project no: 12/03
 project title: Impact 2
 location: Edward Street SHEFFIELD
 drawing no: 009
 drawing title: LEVEL 6 PLAN
 revision: H
 date: Sept 2013
 drawn by: 1:100 @ A1
 approved by:
 scale:
 drawing status: FOR CONSTRUCTION

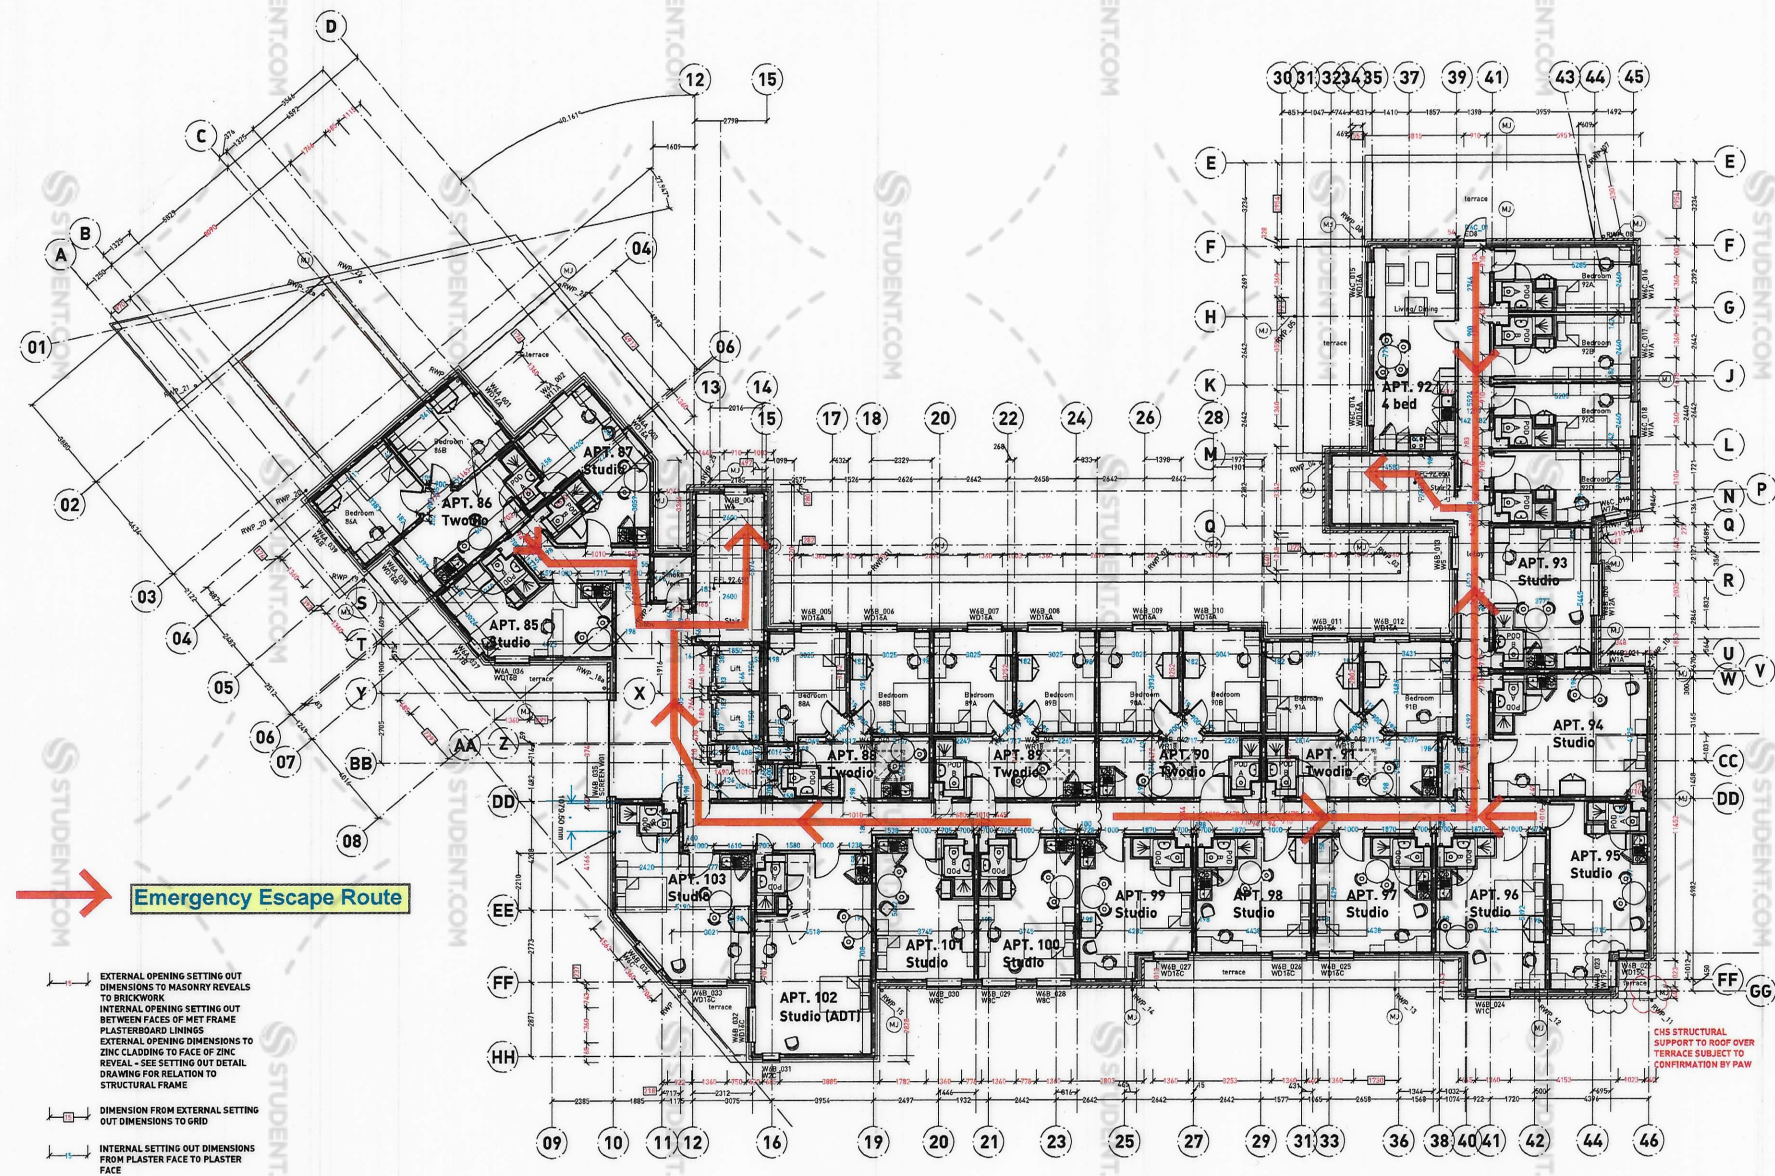
- Revision - Date
 Rev A - 28/09/13
 Internal Structural Opening Setting Out dimensions added, key to dimensions added. Grid 17 corrected 100mm towards grid 18. Note regarding resilient bar in wall added.
 Rev B - 02/10/13
 Issued for construction. Staircase 1 new wall and associated gridline P moved by 552mm to enable staircase walls to align as requested by PAW. Central fire door indicated to coordinate with M&E consultants requirements. Grid Line CC position revised such that wall on grid line between grids 17 & 18 is structural Met Frame. Also wall between Apt 64 and Apt 65 corridor revised to be structural Met Frame. All as requested by PAW. Dry riser added to Stair 2.
 Rev C - 08/10/13
 The columns added, lift openings added, room numbers amended to have letter reference, mobility and ADT (accessible) rooms amended as instructed, finish floor levels added, M&E consultant cladding replacing brickwork to terrace roof beds as instructed, rainwater downpipes added, movement joints added.

Rev D - 11/11/13
 Narrow pod rear doors revised to 700mm & external fire enclosure removed as instructed by contractor, position of fire landing window to stair 1 & mg25 revised, dry riser outside box dims indicated, balcony reference service riser door on G1, lift pod rear door on G1, DD 44-46 all added.
 Rev E - 02/11/13
 Apartment numbers revised.
 Rev F - 08/11/13
 Right-hand references and locations added to Apartment numbers 88-95 amended joint locations along gridline 46 revised as requested by B.Eng.
 Rev G - 20/01/14
 Block B cross corridor walls revised to 100mm thick. Window referencing added.
 Rev H - 10/02/14
 Block B cross corridor walls revised to 100mm thick. Window referencing added. Rev I - 10/02/14
 Kitchen & ensuite layouts indicated, additional plaster face dims added to ALB partitions, window W08_023 type revised.
